EAER calculation VH and VL

The following paragraphs in UN-R-154 would need to be amended:

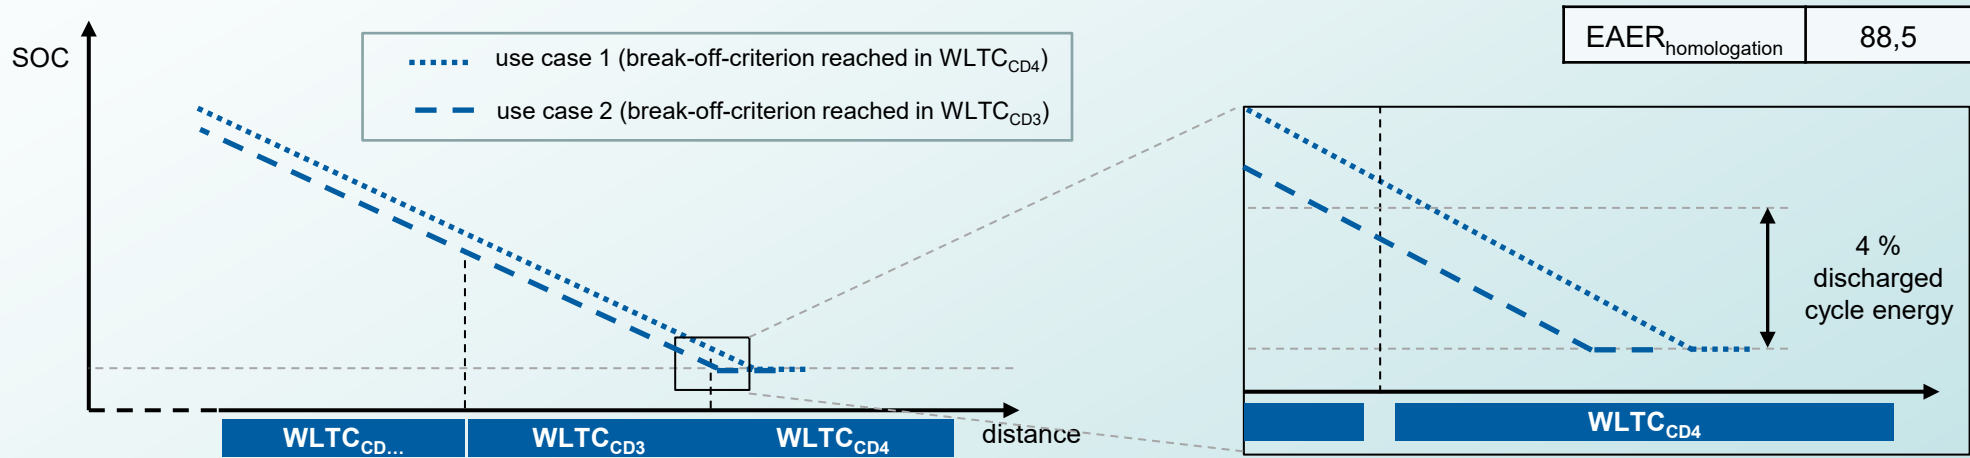
Break-off criterion for the charge-depleting test (less than 4% of cycle energy from REESSs) influences R_{CDC}

→ resulting EAER different → resulting SOCR indicator different → **Will lead to problems in context of EVE-GTR**

In context of an individual vehicle @ ISC (e.g. EVE-GTR) it is necessary to refer to the R_{CDC} -value determined during type approval.

→ This eliminates the impact of the break-off-criterion on R_{CDC} and therefore on EAER for ISC-testing.

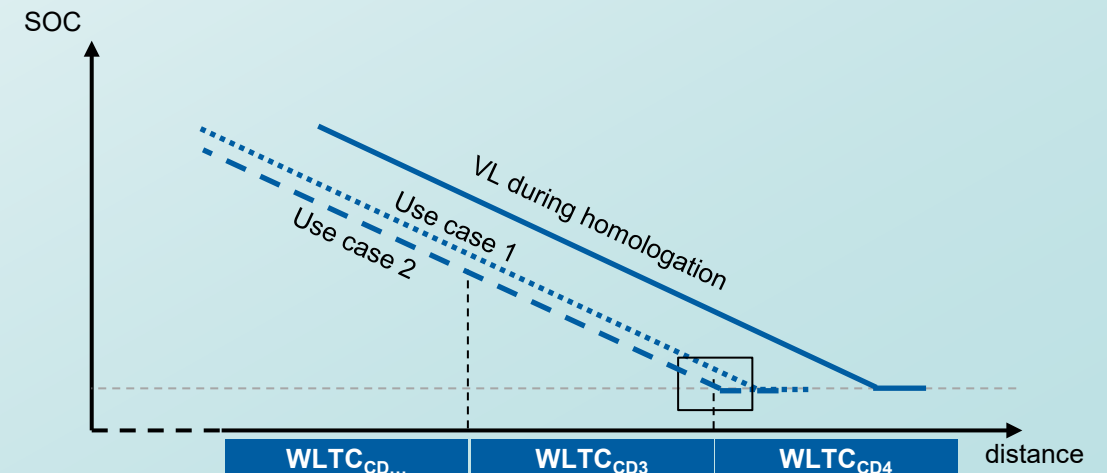
→ In case of different R_{CDC} -values at homologation for VH and VL, some individual vehicles close to the break-off criterion (4% threshold) would lose EAER caused by the calculation method

→ Way forward to resolve this problem is just one R_{CDC} -value for the purpose of EAER calculation within one IP-family → R_{CDC} of vehicle L
